Product Update

Title: DS Vision Receiver Long / Video Tuning unit compatibility

No: 200711-02

Summary: Firmware for improved compatibility between Receiver Long and Video Tuning Unit.

Figure 1 Service window

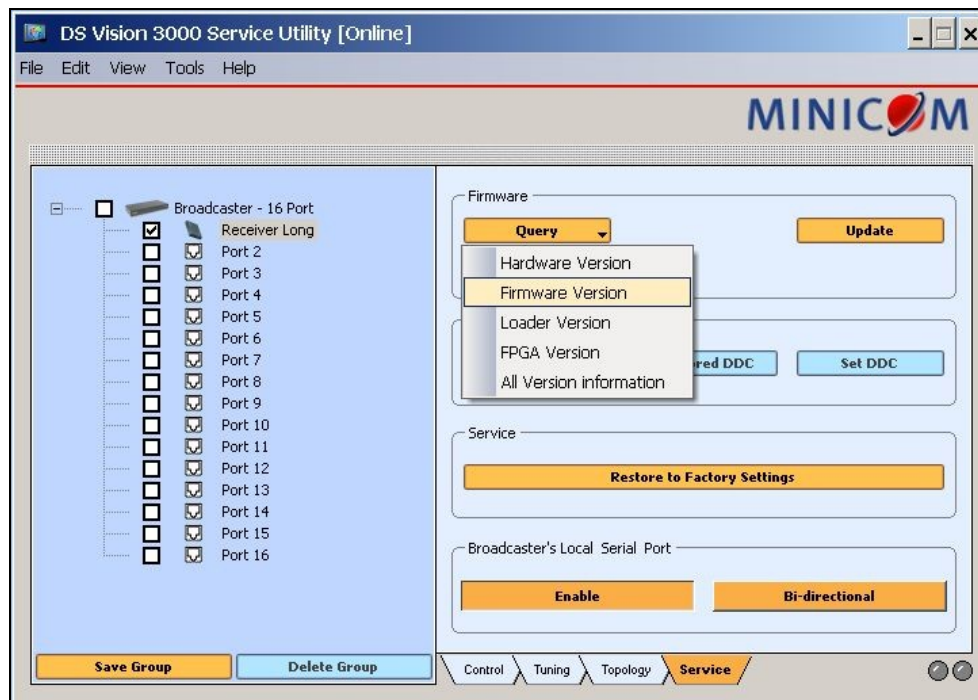
1. Select the unit that needs to be upgraded.
2. Click on **Query** Button. Select firmware version.
3. Unit's firmware version will appear in version line.
4. To update the device click the **Update** button.
5. Browse and locate the firmware file.

Figure 2 Update window

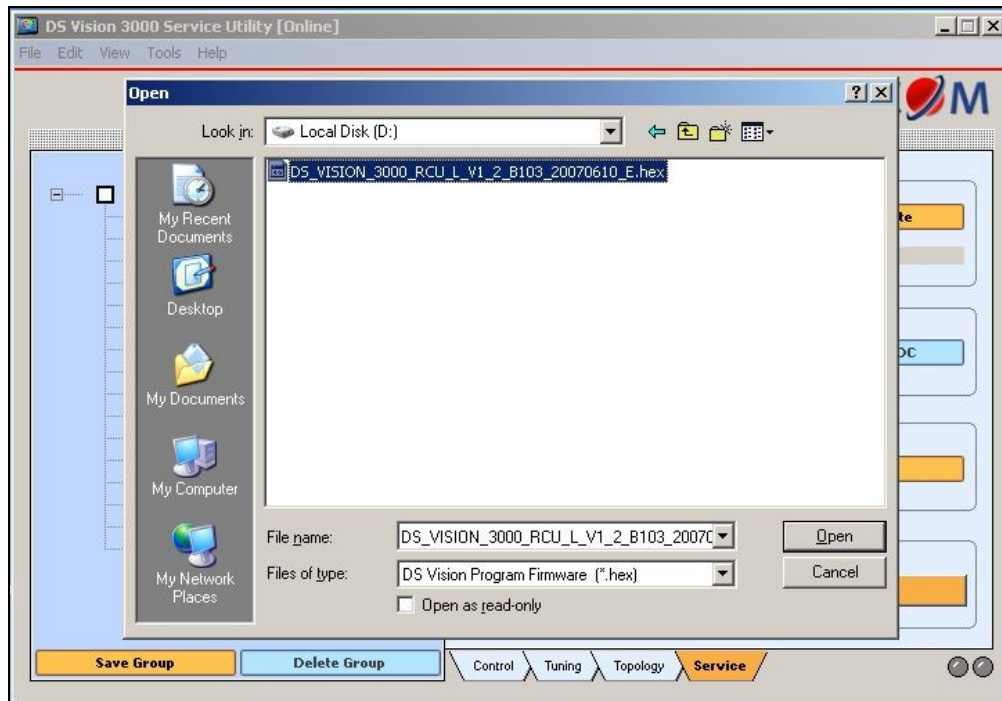
6. The upgrade will start immediately after opening the file.
